RE: Northlake (Formerly Greenbriar) Welcome Center (DR19-251)

WALKSacramento has reviewed the project routing for Northlake (Formerly Greenbriar) Welcome Center. We offer the following comments to enhance the project's contribution to walking and biking by future Northlake residents.

Recommended Additional Pedestrian Access (Primary Route with steps in purple and Accessible Route in red)

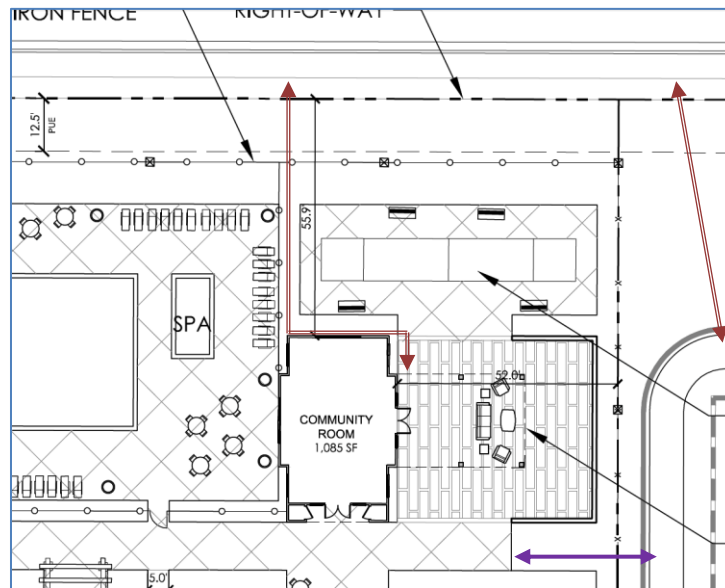
1. **Add a pedestrian connection between the Lakewalk pedestrian promenade and the sidewalk adjacent to the Community Room building.** This would allow people arriving via the promenade to walk directly to the Community Room and the Welcome Center without having to walk south to the closest sidewalk access point. The primary route would provide the most direct access and, perhaps, it would establish an attractive view that would draw people to the Lakewalk.
